**TRANSPORT AND URBAN DEVELOPMENT COMMITTEE**

**AGENDA**

**Time:** 9:15 am  
**Date:** Wednesday, 4 May 2016  
**Venue:** Committee Room 1  
Ground Floor, Council Offices  
101 Wakefield Street  
Wellington

1. To provide a copy of the submissions and a list of submitters making oral submissions in support of their written submissions on the Hutt Road Cycle Path consultation.

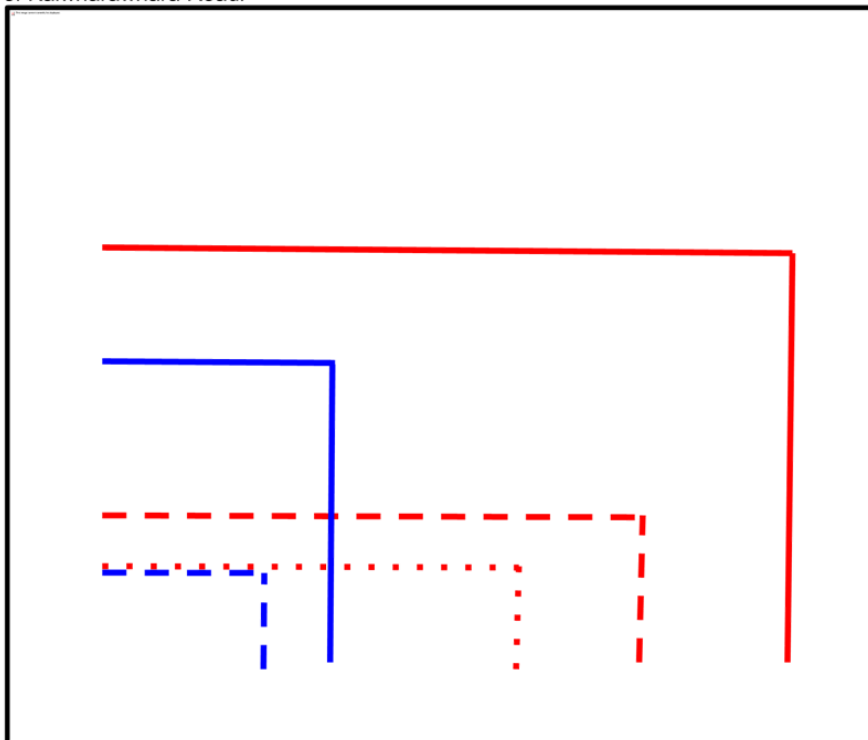
However, the report deems NZ standards to be insufficient for NZ conditions and turns to an Australian standard (VicRoads Cycle Note 21).

The VicRoads diagram below shows the current usage (in blue) and assumed usage (in red) for cycling & walking use along Hutt Road both north (solid line) and south (dashed line) of Kaiwharawhara Road:

The WCC report combines the VicRoads metrics with the assumed future of cycling use actually tripling in the next 2 decades to provide an even wider an alternative solution assessment (Table 19):
